#### **4.2 Update Report for Rezoning Application No. 00485 for 2330 Richmond Road**

**Subject:** Update Report for Rezoning Application No. 00485 for 2330 Richmond Road

**Subject:** Rezoning Application No. 00485 for 2330 Richmond Road

Proposed Site Plan of 2330 RICHMOND ROAD

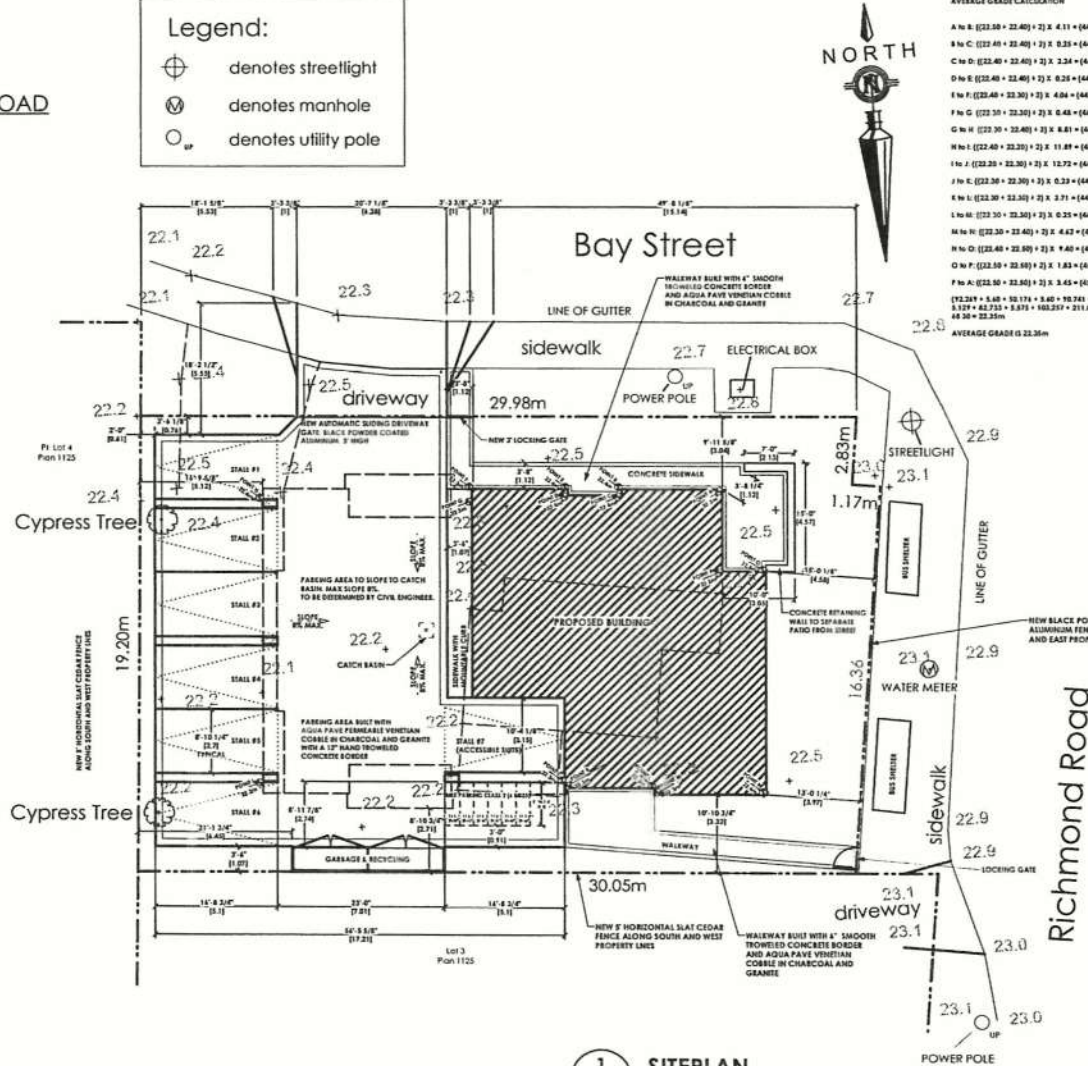
The parking area is shown as asphalt paving and it was questioned if permeable paving could be used or any other environmentally friendly alternative due to the site being contained in the Bowker Creek Watershed. The designer advised that infiltration chambers will be used.

PROPOSED LANDSCAPE PLAN for  
ORLANDO DELUSIC  
2330 RICHMOND ROAD

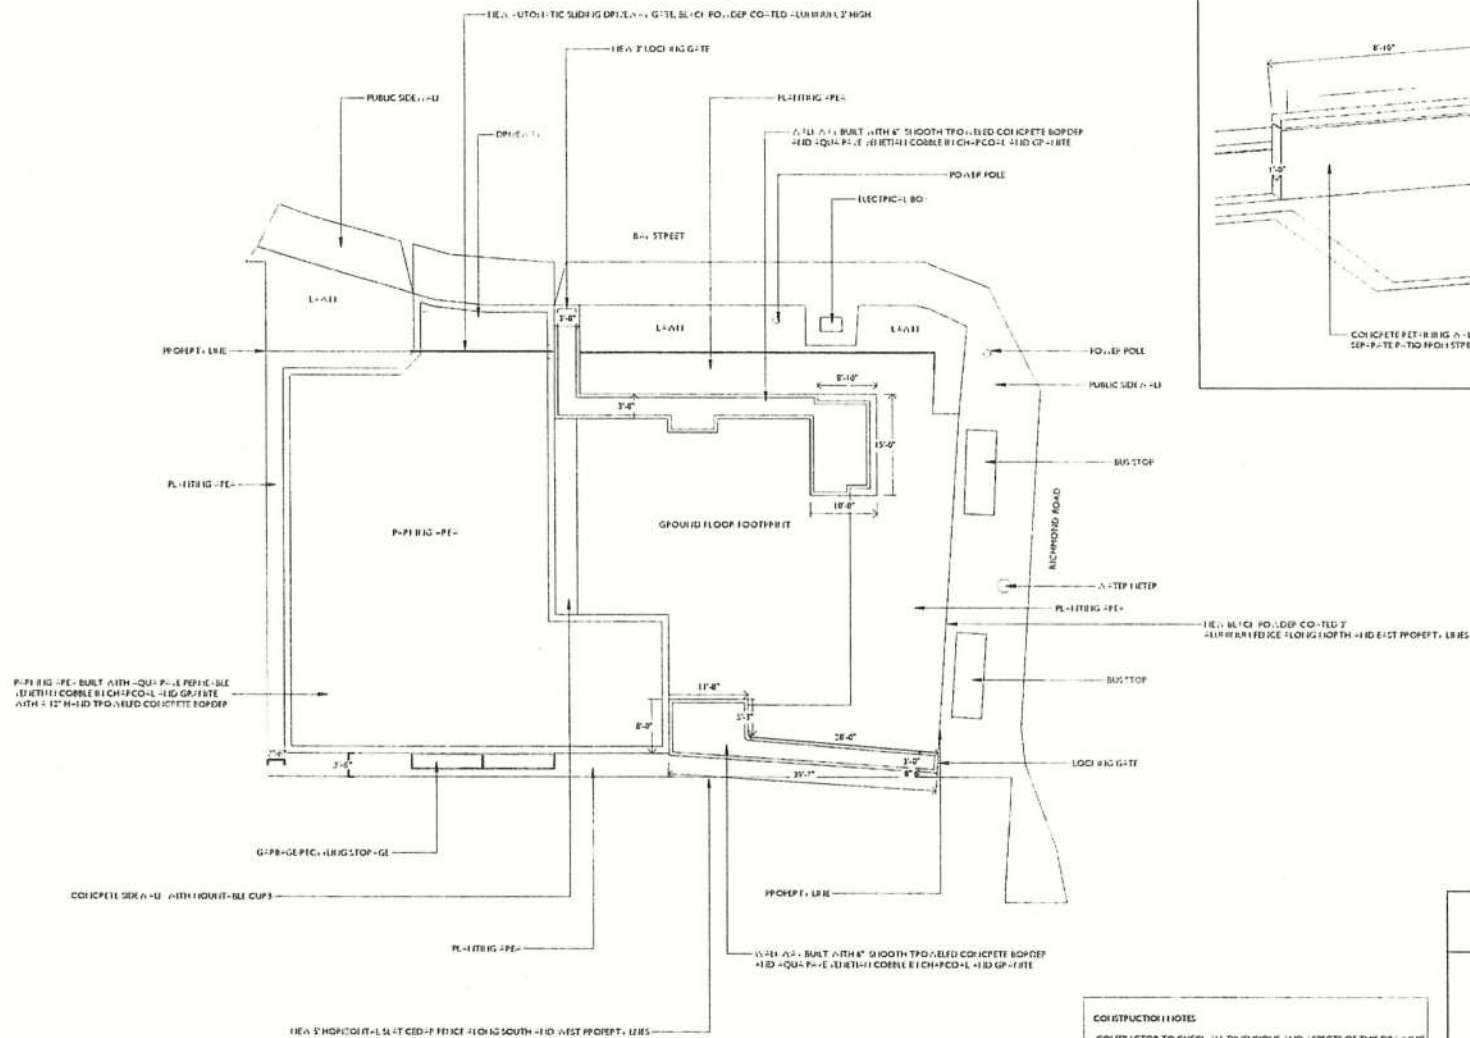
The site plan indicates an asphalt parking area with concrete sidewalks. The developer's letter submitted with the Rezoning Application lists permeable pavers for the parking area. However, the landscape plan indicates walkway built with 6" smooth troweled concrete border and Aqua Pure Venetian Cobble with the parking area consisting of the same permeable material. Our LUC wishes to confirm that permeable materials will be used.

Landscape plan fencing is shown as black powder coated 3 ft. aluminum. Site plan indicates a height of 5ft. Which height will be used?

The landscaping plan indicates grasses and ferns on West and North side of property. Could taller shrubs and or trees be used to screen the family home on the North side? There are two cypress trees shown on the site plan, West Side...will these be protected during construction? If not, could taller trees also be used for screening?
